# MONTGOMERY COUNTY PLANNING DEPARTMENT

SUBJECT: Mandatory Referral No. 2010709-DGS-1: EMOC Casey 6 and 7 and  
Mandatory Referral No. 2009749-DGS-1: Site Selection for Robert's Oxygen  
Property , I-3 Zone

### STAFF RECOMMENDATION: *Approval To Transmit Comments to the County Executive*

Attachment D: Landscape Plan Casey 6

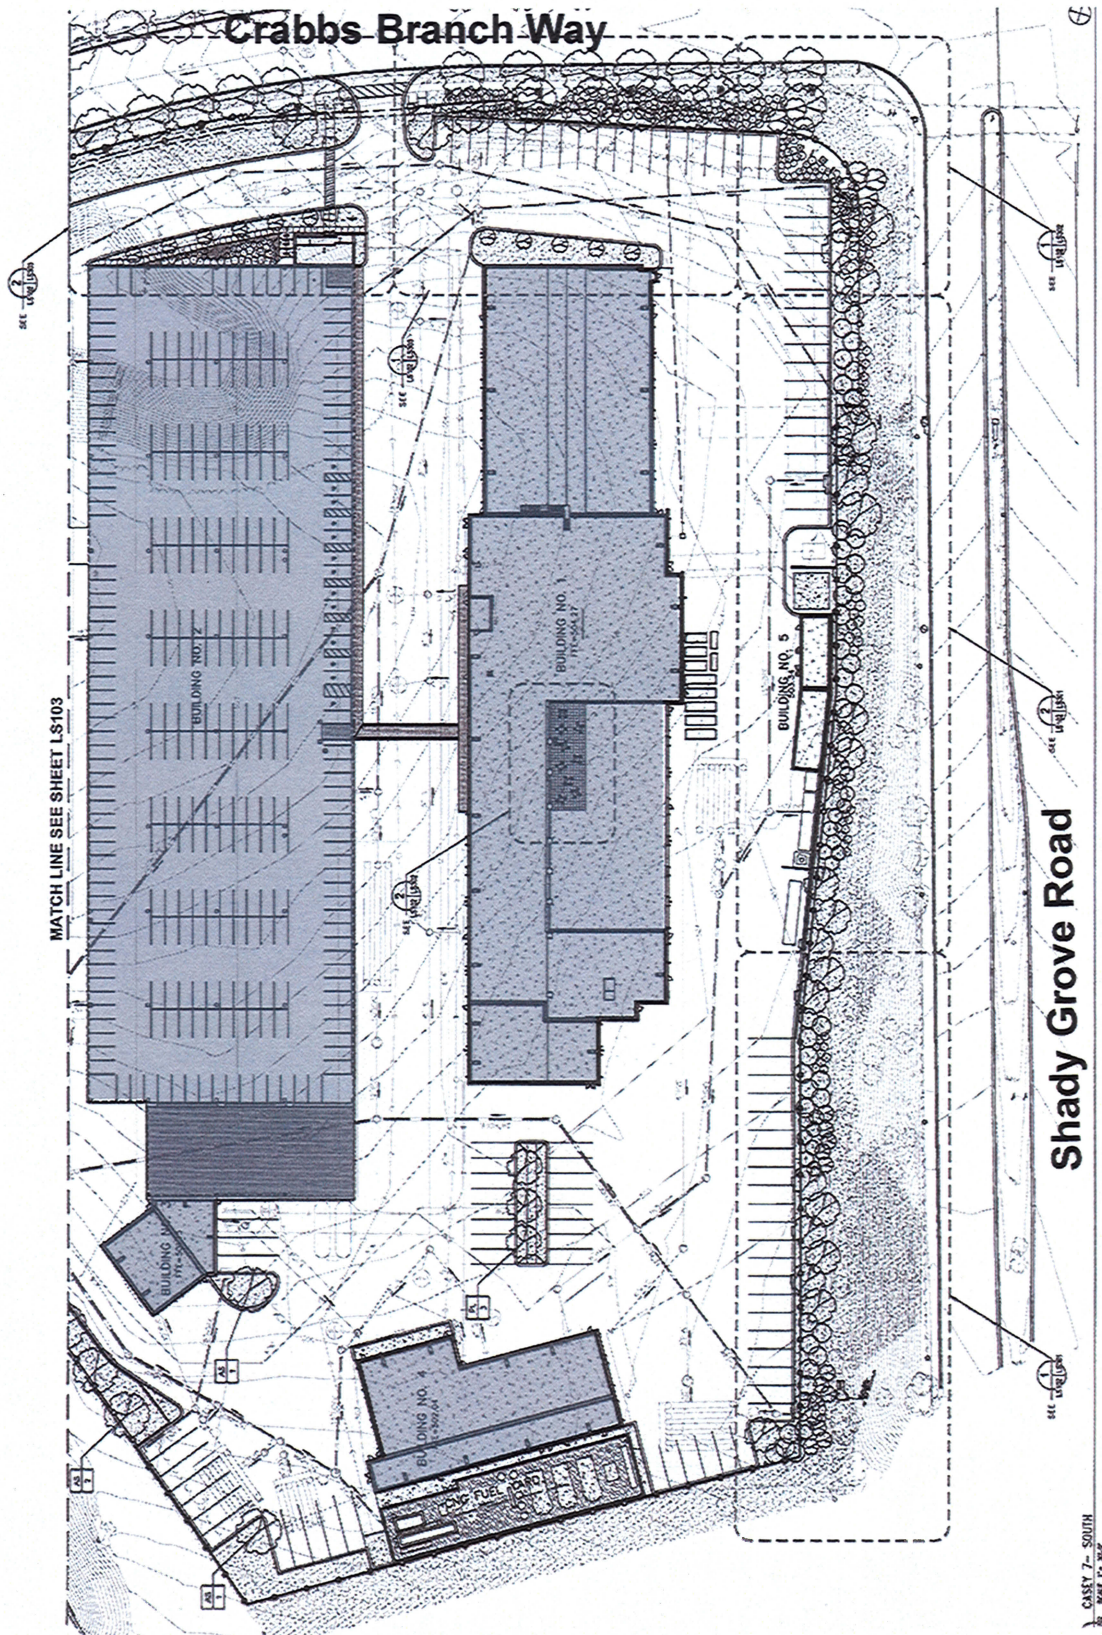
Revisions to the submitted planting plans are in needed to improve screening along several of the roadways. Staff's understanding is that the County proposes to revise the drawing as follows:

### **Shady Grove Road**

- North of the existing drain pipe, preserve large existing trees and clear out brambles and honeysuckle. Increase screening where needed to screen views of the Transit Fleet Management's two story building with maintenance bays that face Shady Grove Road. The grade drops from Shady Grove Road down to the maintenance bays and this will help diminish views of the facility.
- South of the existing drain pipe towards the intersection with Crabbs Branch Way, the existing vegetation will be cleared, regraded and intensely planted. A solid, masonry wall is also proposed to hide the facility from views from the intersection.

### **I-370**

- Along a segment of I-370, just past the CXS underpass, plant native shrubs such as Sumac to screen views into the site from the highway. This will require permission from the State Highway Administration.

### **Within Casey 7**

- Revise the planting plans for areas in front of the buildings facing Crabbs Branch Way to increase the shade trees to provide shade and buffering of the building facades.

Attachment D: Landscape Plan Robert's Oxygen

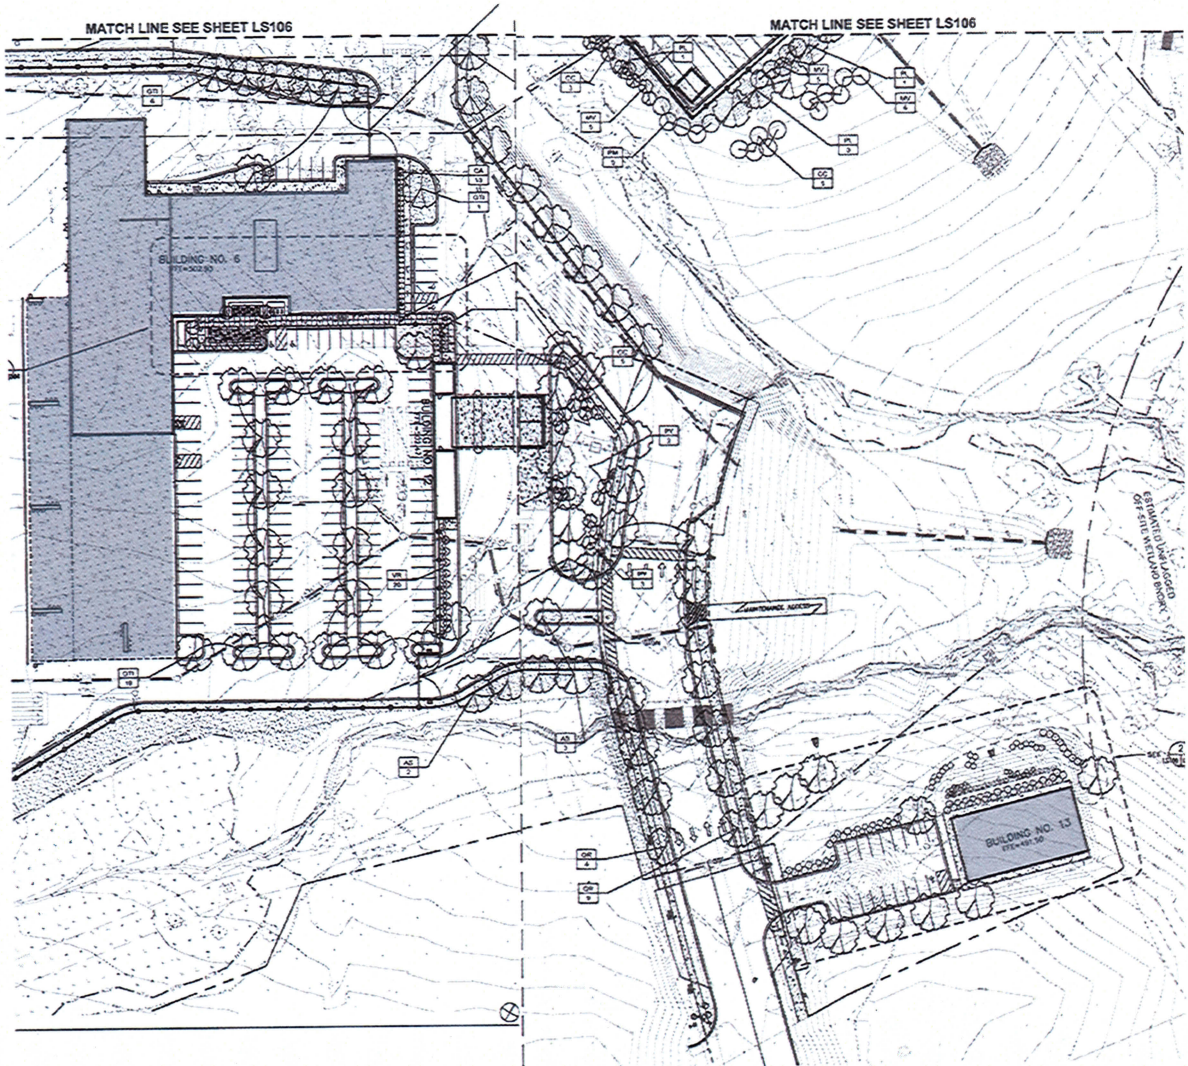
On Robert's Oxygen Property, lighting is a special concern given the close proximity of residences. The lighting plan shows low light levels along the edge of the property but locates several 60 foot poles with clustered spot lights in the center of the site that will be seen over the one story salt and sand shed. Light levels under the spot lights is approximately 46 foot candles. This is an excessive light level. Staff suggests that this level of lighting be reduced to a level that still provides for safe functioning of equipment.

- We have been told that mature trees will be planted on the berm adjacent to Washington Grove. These, however, are not shown on the Forest Conservation Plan. We think this makes sense because it ensures trees at that location in the future and complies with the Shady Grove Sector Plan, which requires a 50-foot forested buffer area.

- We would like a clarification of the proposed ingress/egress noted on the Site Plan between Roberts Oxygen and the railroad tracks. We oppose anything other than an emergency exit at that location and would like to see that it normally would be blocked from traffic. Even as an emergency exit it poses very serious safety issues due to its proximity and angle to the crossing and should be reconsidered.

- To mitigate the impact of some of the non-permeable surface on the Roberts Oxygen site, we request consideration of some strategic plantings to break up the continuous asphalt surface and reduce the heat island impact on the neighbors. This would help both with run-off from the site and mitigate incompatibility with the adjoining residences.

- We urge you to extend the berm and 50-foot forested buffer along the Town boundary to Railroad Street. Although this is not on the Site Plan, this will be required under the Shady Grove Sector Plan and is important to consider in negotiations with Roberts
